1977 Corvette: Service Bulletin: Anti-Theft Alarm System Interim Modifications

Source: Chevrolet Dealer Service Bulletin

Bulletin No: 77-I-38

Date: May 1977

FIGURE 1

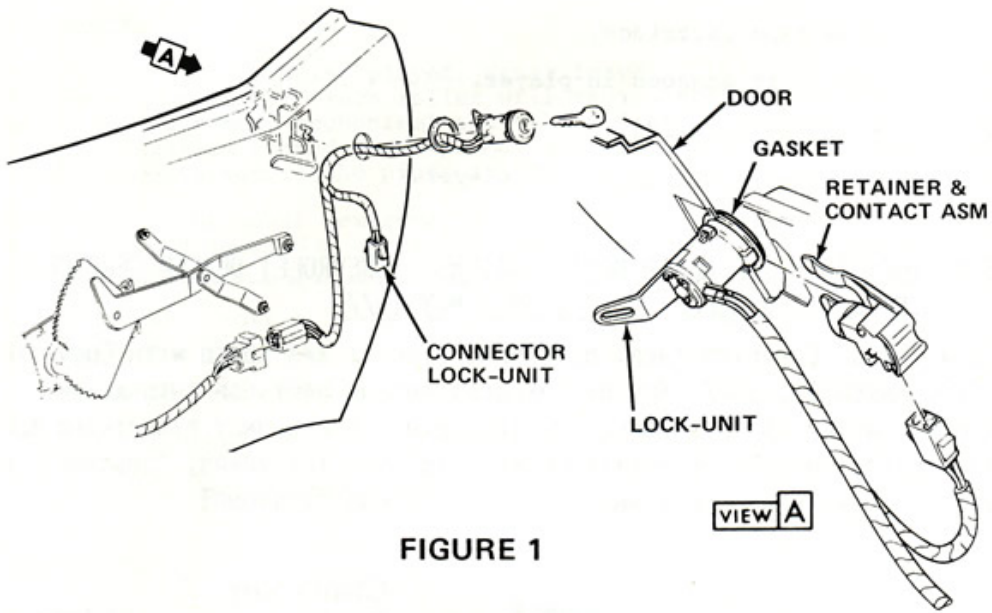
- The actuating switch for the system is no longer located on the left front fender. It has been incorporated into the left front door lock and must be activated by locking this door with the key from outside of the vehicle (Figure 1). This is the only way the alarm can be set. Turning the inside door knob to the locked position when exiting the vehicle will not activate the alarm system.
- The anti-theft alarm system horn has been moved from the left rear inner fender to the far left side of the engine compartment dash panel. (Figure 2).
- The anti-theft alarm system flasher assembly is now located on the console trim plate (Figure 3), rather than the rear compartment underbody panel.
- The new anti-theft alarm system wiring diagram is illustrated in Figure 4.
